Access Compliance Report Public Rights-of-Way (Curb Ramps)

Main Street: ARGYLE_DR Cross Street: OAK_KNOLL_DR Location: NE

ADA ID: RPAT211206132321 Ramp Type: Type 1 - Perpendicular Diagonal Initial Pass/Fail: Fail Overall Compliance: No Severity Score: 15

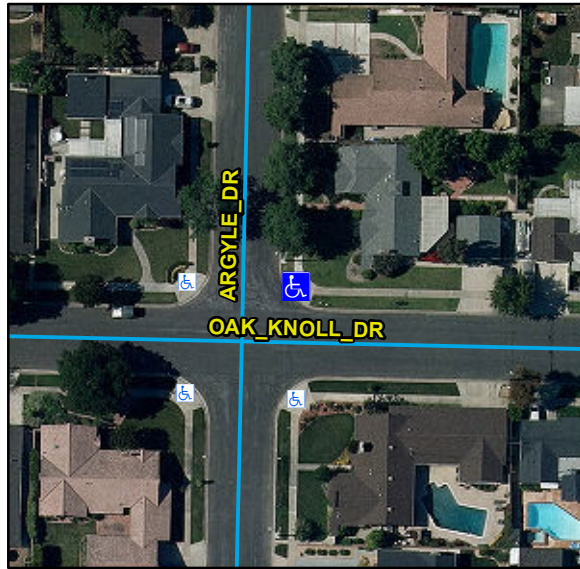
Compliance	Description	Data	Compliance	Description	Data
N/A	Ramp Length (in)	81	N/A	Flare Type LT	
Yes	Ramp Width (in)	48			N/A
No	Ramp Run Slope (%)	8.8	N/A	Flare Slope LT (%)	N/A
Yes	Ramp Cross Slope (%)	0.3	N/A	Flare Traversable LT	N/A
N/A	Landing Present	N/A	N/A	Flare Type RT	
N/A	Landing Length (in)	N/A			N/A
N/A	Landing Width (in)	N/A	N/A	Flare Slope RT (%)	N/A
N/A	Landing Run Slope (%)	N/A	N/A	Flare Traversable RT	N/A
N/A	Landing Cross Slope (%)	N/A	N/A	DWS Provided	N/A
N/A	Landing Movement Obstructed?	N/A	N/A	DWS Contrast	N/A
	Landing Movement Type	N/A	N/A	DWS Length (in)	N/A
N/A	Landing Shared	N/A	N/A	DWS Full Width	N/A
N/A	Clear Space	Yes	N/A	DWS Offset Left (in)	N/A
N/A	Clear Space To Crosswalk (in)	N/A	N/A	DWS Offset Right (in)	N/A
N/A	Marked Crosswalk 1	No	N/A	Marked Crosswalk 2	No
	Crossing 1 Direction	W		Crossing 2 Direction	S
	Marked Crosswalk 1 Width (in)	N/A		Marked Crosswalk 2 Width (in)	N/A

N/A	Ramp Inside Crosswalk 1	N/A	Yes	Ramp Inside Crosswalk 2	N/A
	Crossing 1 Slope (%)	4.5		Crossing 2 Slope (%)	3.8
	Crossing 1 Cross Slope (%)	0.7		Crossing 2 Cross Slope (%)	2.4
N/A	Gutter Ponding	N/A	No	Curb Slope	13.1
Yes	Gutter Lip Height (in)	0		Road Run Slope (%)	0.7
N/A	Gutter Run Slope (%)	N/A		Road Cross Slope (%)	5.1
N/A	Gutter Cross Slope (%)	N/A			
Yes	Overall Surface Condition: Acceptable		No	Perp Joint Present	No
	Cross Gutter Present?	No		Spandrel Present?	No
	Replace Cross Gutter?	N/A		Replace Spandrel?	N/A

Remove & Replace Curb Ramp With Two New Directional Ramps or Equivalent.

R304.2.2, R204.3, STD 1115
